RPRC RETURN LETTER

Application Number: 2021-0721

Street Location: 9 Quaker Meeting House Road

RE: Lazar Residence – 9 Quaker Meeting House Road – TaxID: 108.03-1-18

GROSS LAND COVERAGE SCHEMATIC

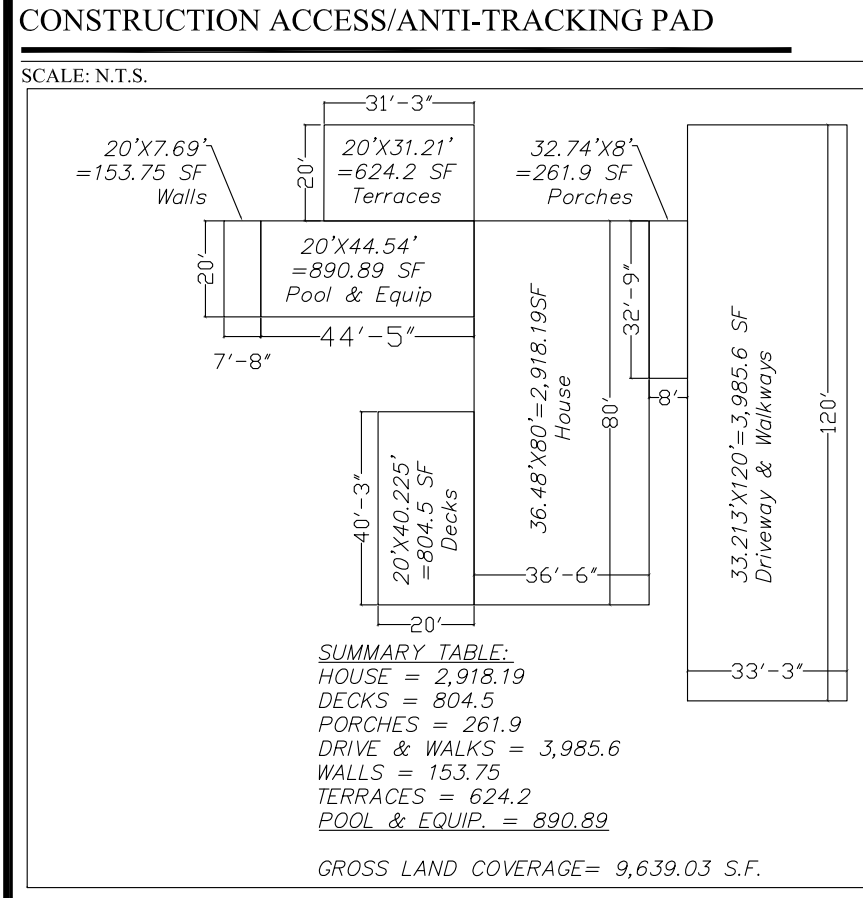
- The Applicant is within 13 feet of the maximum permitted gross land coverage. The Applicant should submit a GLC backup exhibit that graphically depicts all existing and proposed GLC with the square footage of each element (see GLC worksheet instructions for further detail).

3. The Applicant is within 13 feet of the maximum permitted gross land coverage. The Applicant should submit a GLC backup exhibit that graphically depicts all existing and proposed GLC with the square footage of each element (see GLC worksheet instructions for further detail).

Response: The gross land coverage has been adjusted per minor modifications to the site plan. As per the original application the GLC backup graphic is included on sheet RPRC-1.

SITE PLAN
RPRC PERMIT PLAN

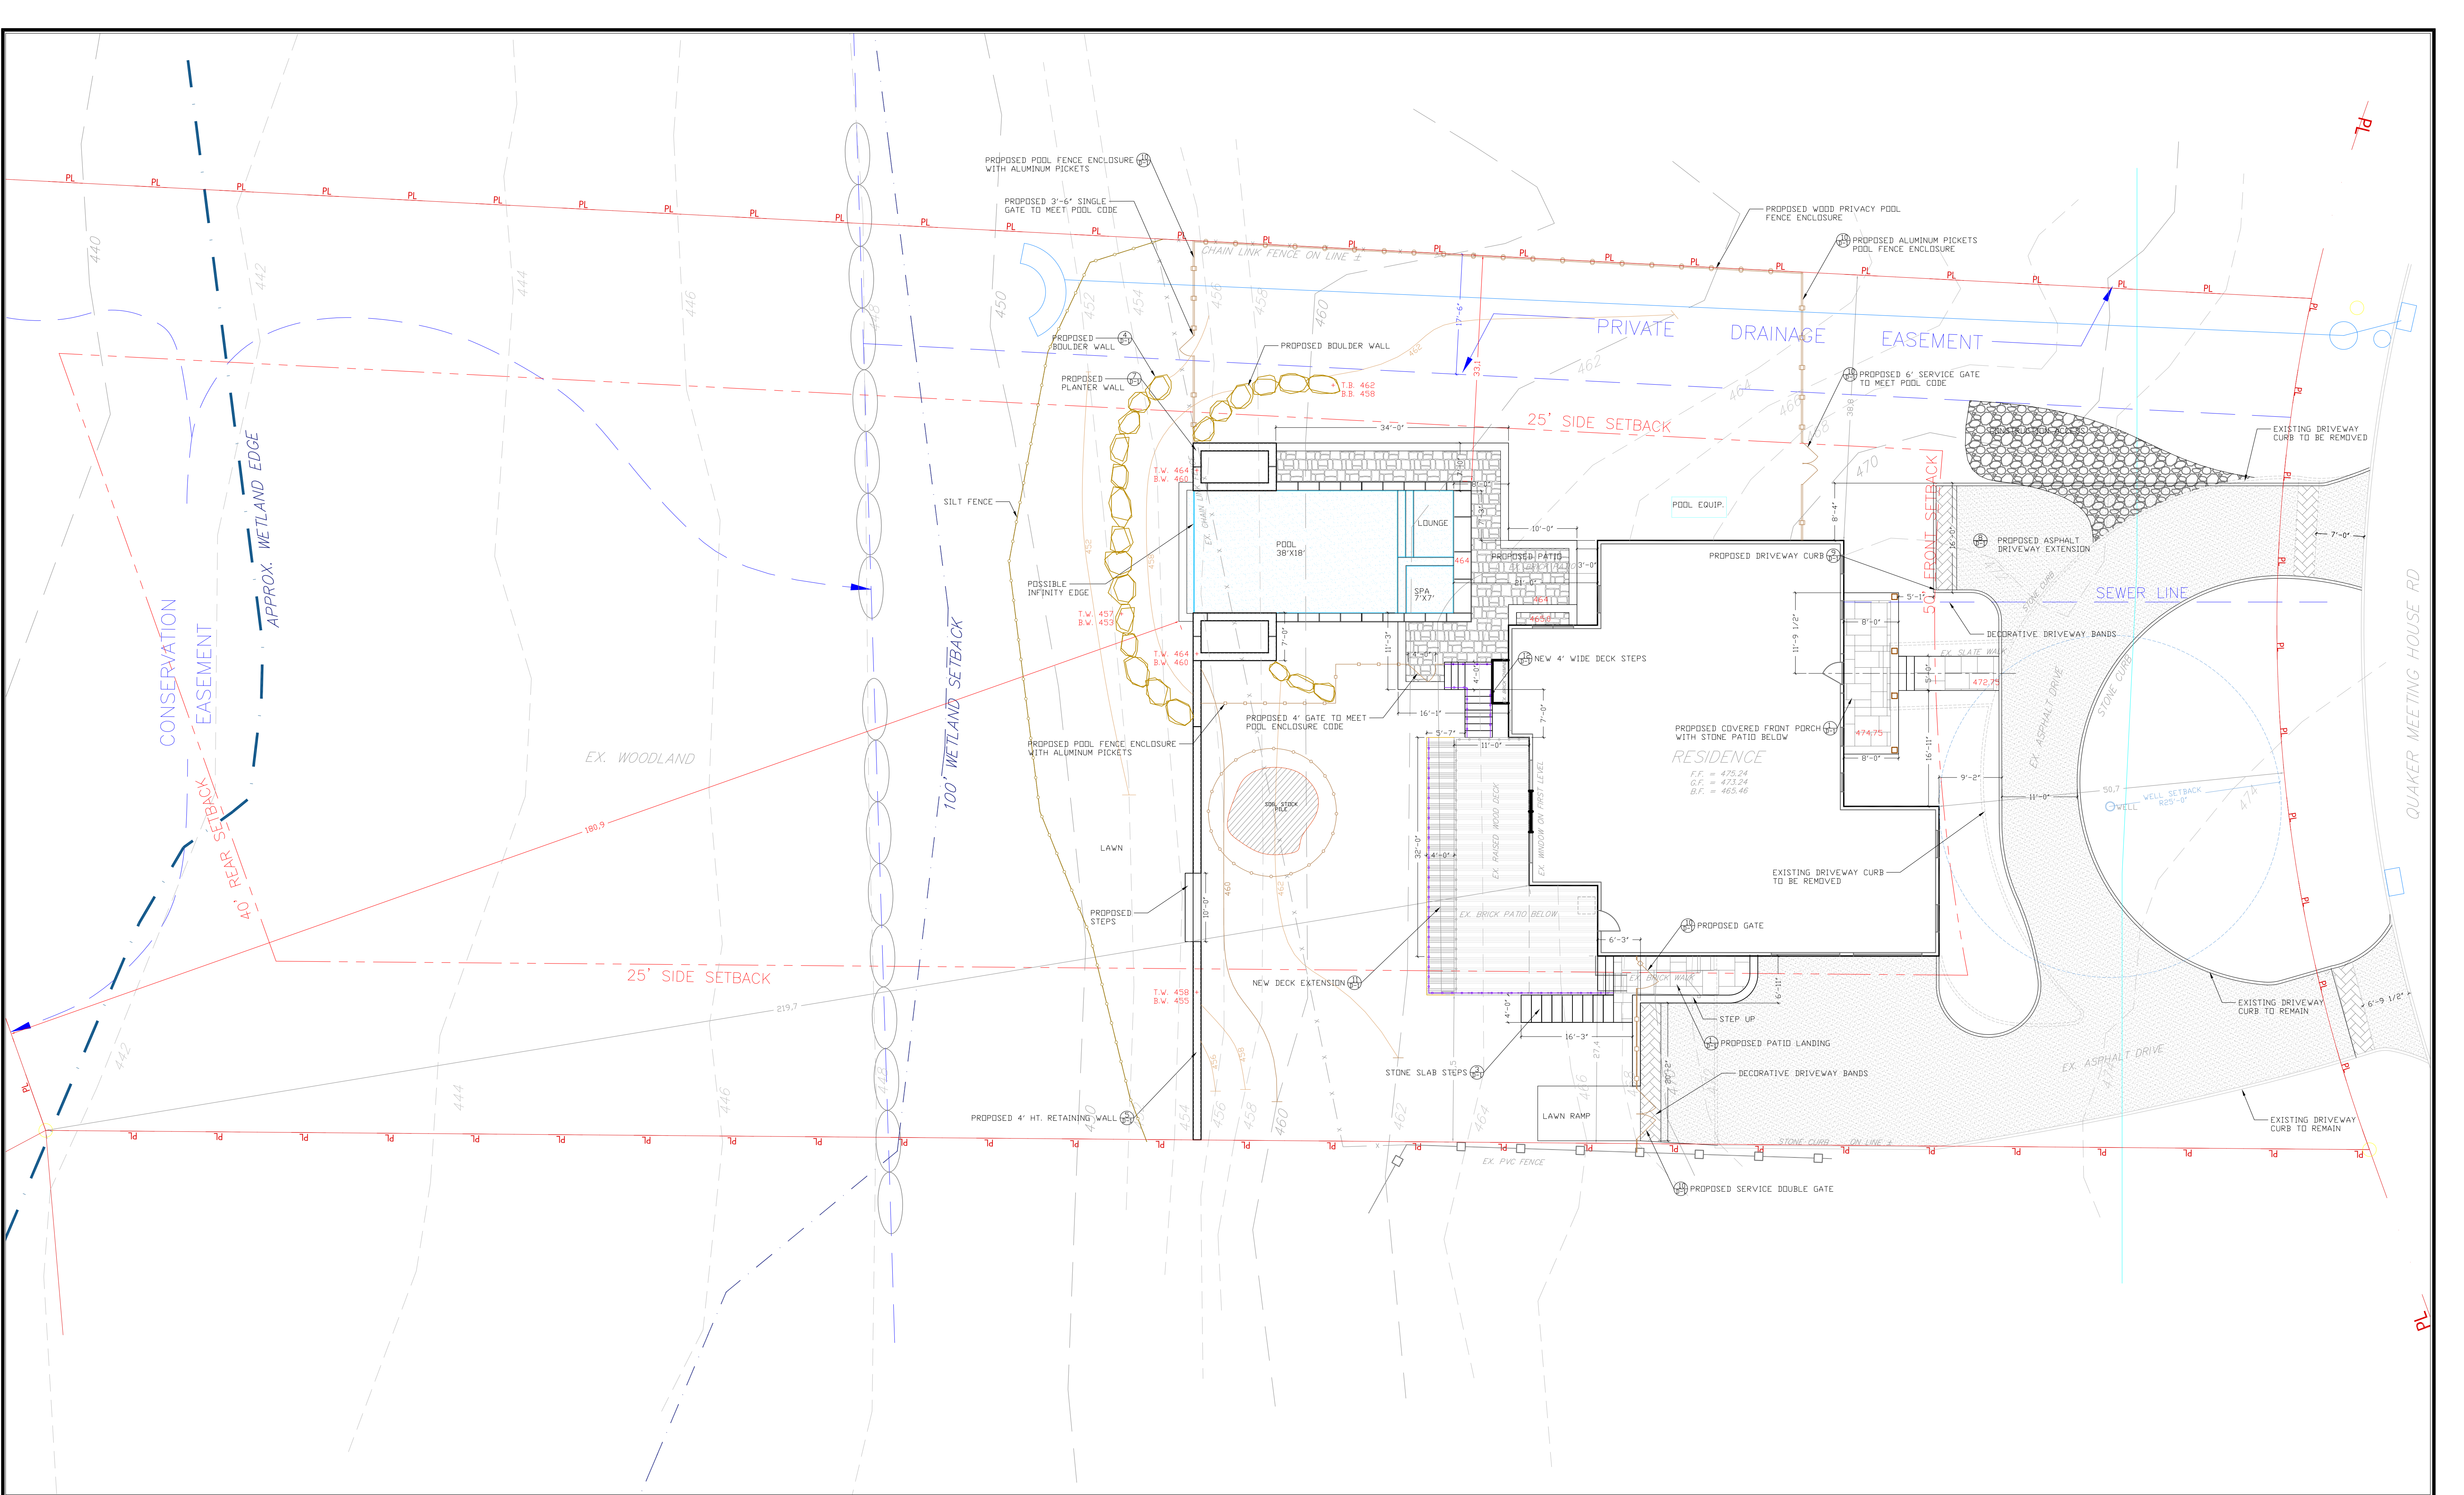
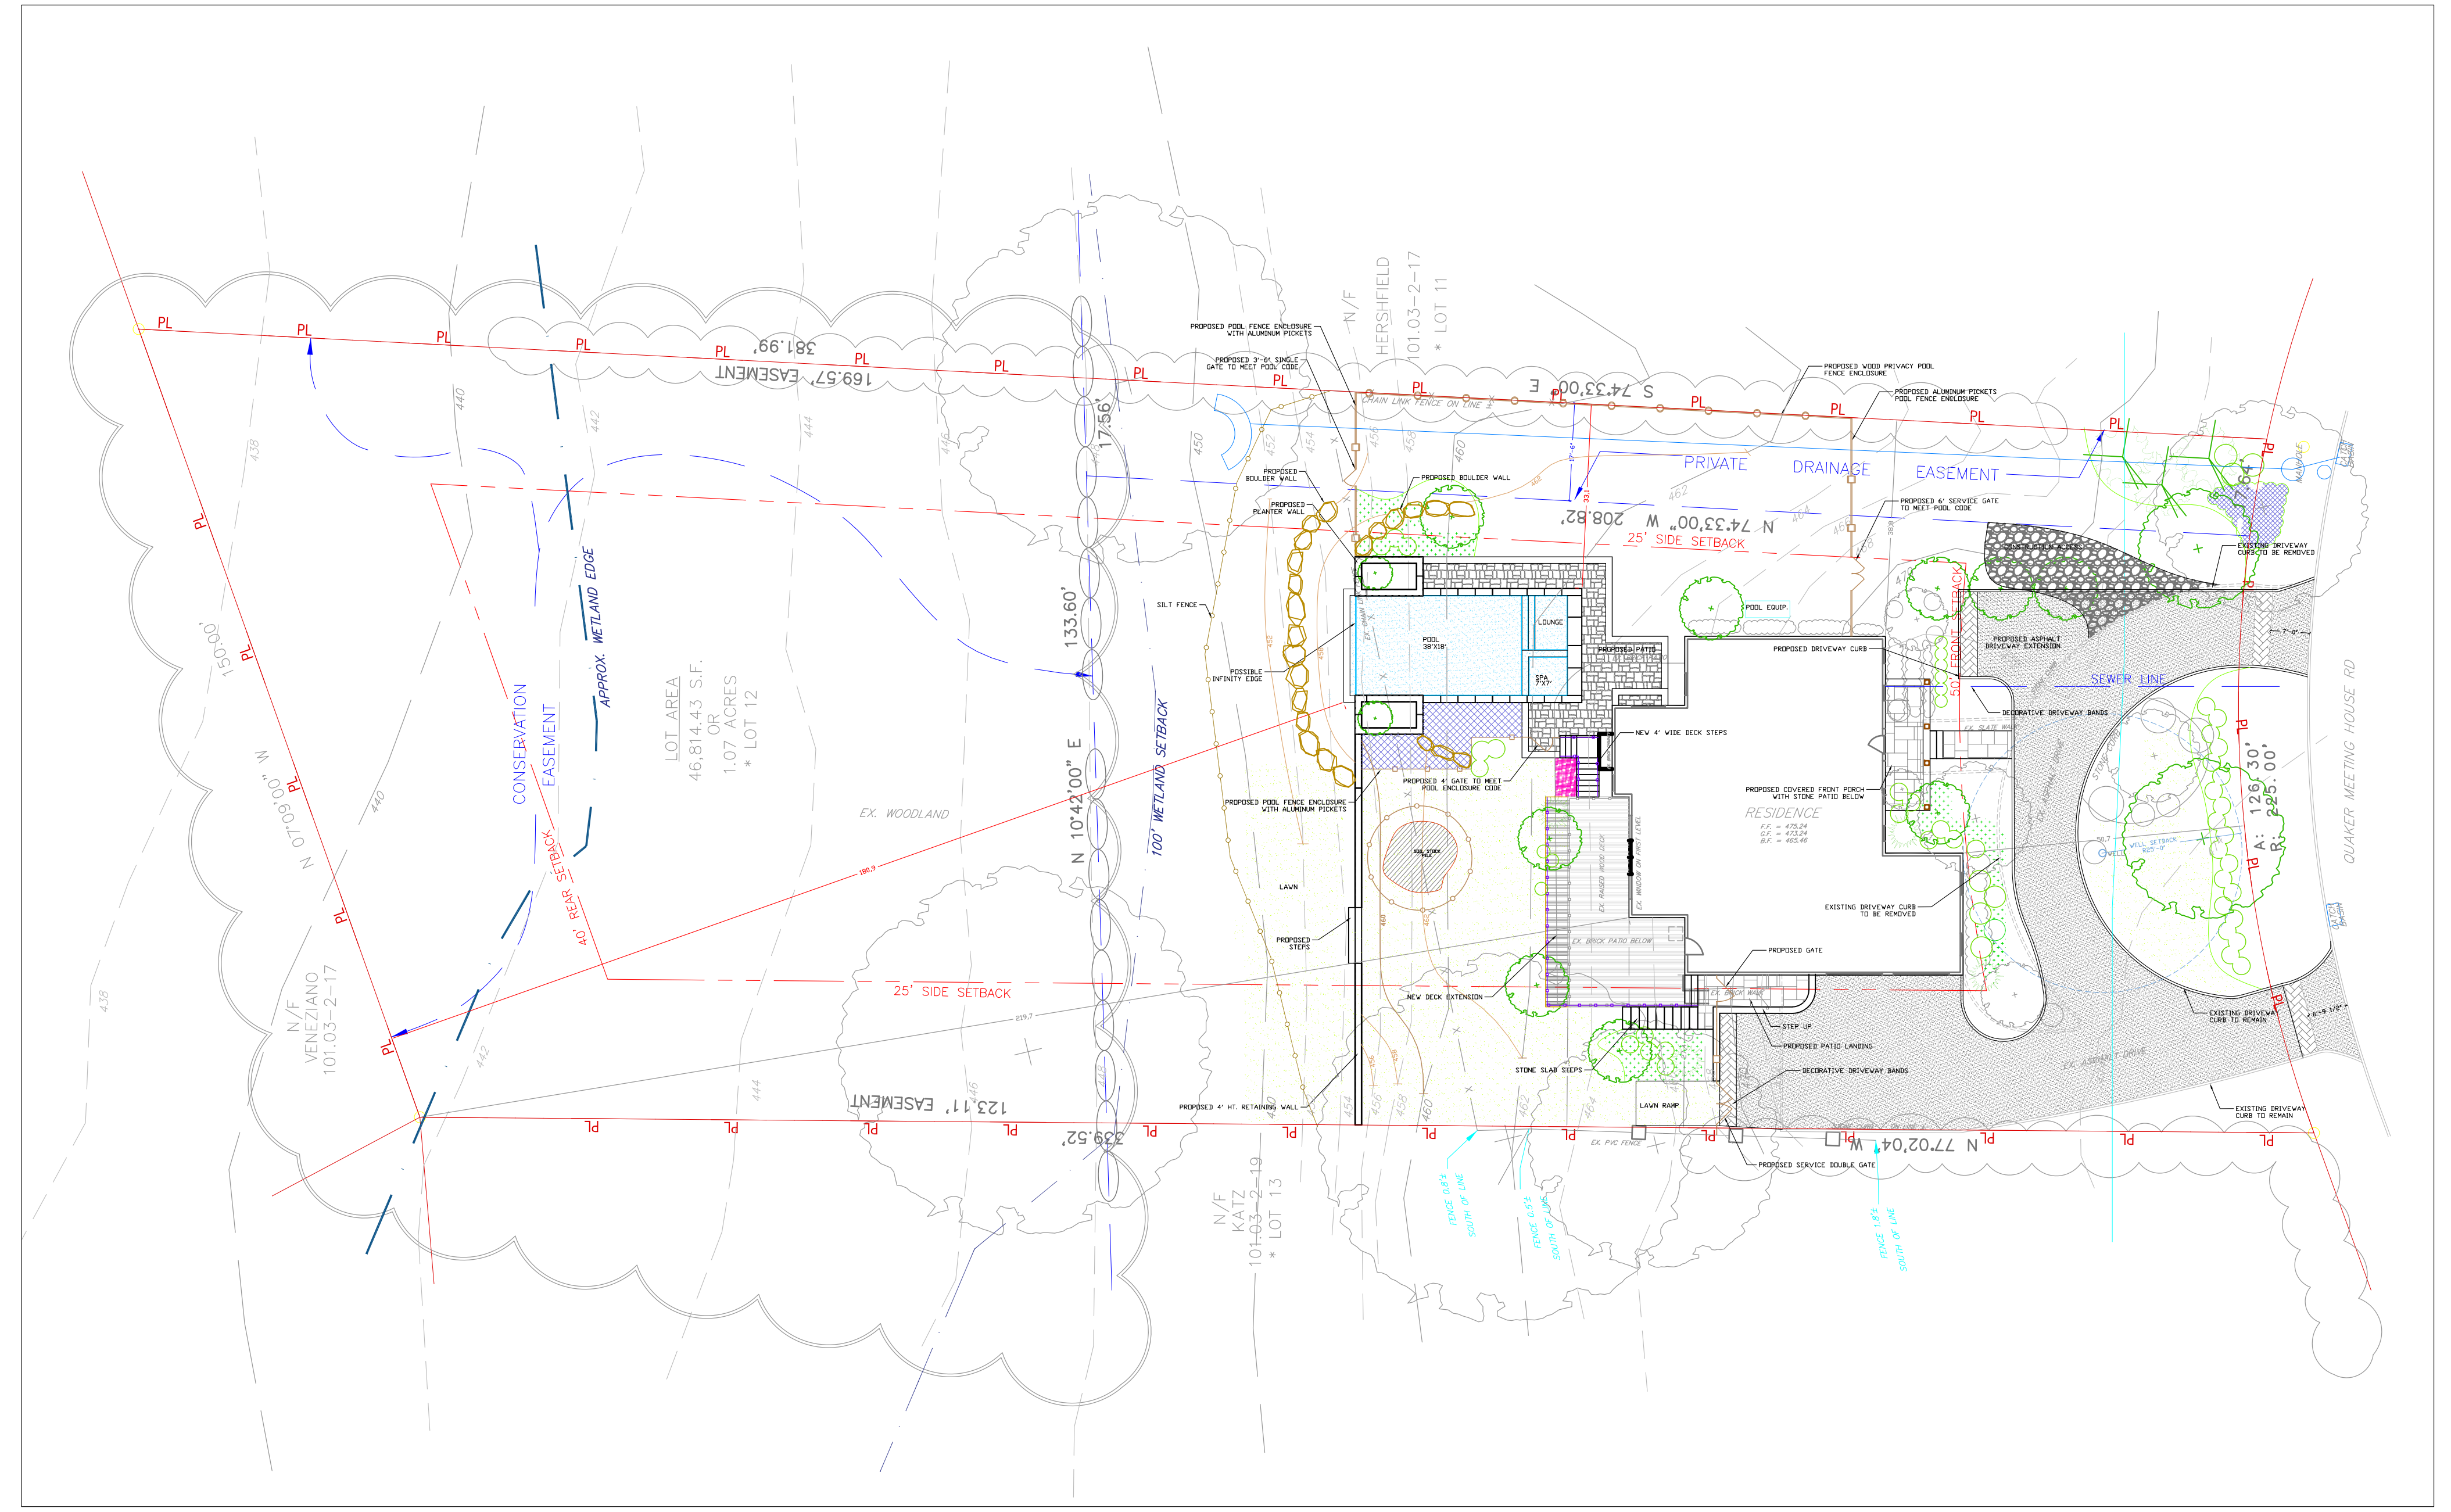
- The deck addition that does not meet the minimum side yard setback shall be removed or the Applicant will need to seek a variance from the Zoning Board of Appeals.

- The proposed decorative driveway bands located in the Quaker Meeting House ROW should be relocated to be [five feet off the curb](#) per Highway Department regulations.

- The proposed tree in the Quaker Meeting House ROW should be relocated to the subject parcel.
- The proposed nature path should be removed from the plans.

- The project plans include an approximate wetland boundary which differs considerably from the wetland boundary shown on the Leisure Farm Subdivision Filed Map. The wetland boundary touches the retaining wall at the southern property line and extends northerly to a point on the northern property line which is midway between the retaining wall and wetland edge shown on the applicant's site plan. If the Filed Map wetland boundary was used, a majority of the proposed improvements would be located within the wetland buffer and a Wetland Permit would be required for the project. The applicant will need to have the wetland boundary flagged in the field by a Wetland/Soil Professional and verified by the Town Wetland Consultant. Please notify the Town Engineer once the wetland boundary has been established in the field. Upon verification, the wetland flags will need to be surveyed and boundary included on the Site Plan.

2. The proposed decorative driveway bands located in the Quaker Meeting House ROW should be relocated to be five feet off the curb per Highway Department regulations.

4. The proposed tree in the Quaker meeting House ROW should be relocated to the subject parcel.

11. Please show all existing wells within the area and confirm the infiltration system complies with the setback requirements from the wells.

Response: At this time the application would like to proceed with the deck location as represented on the plan and will seek a variance from ZBA.

Response: The proposed bands are located 7' from the curb and we have noted a dimension on the plans.

Response: All planting has been relocated out of the ROW and onto the property.

Response: A site visit was conducted with Jan Johannessen from Kellard Sessions Consulting on August 17th, 2021 at 9am to review the wetlands boundary delineated on the plan using the WCGIS data. Per Jan's review, he noted that the WCGIS line reflected actual field conditions and can be used.

Response: The existing well is shown in the front of the house in the center island of the looped driveway.
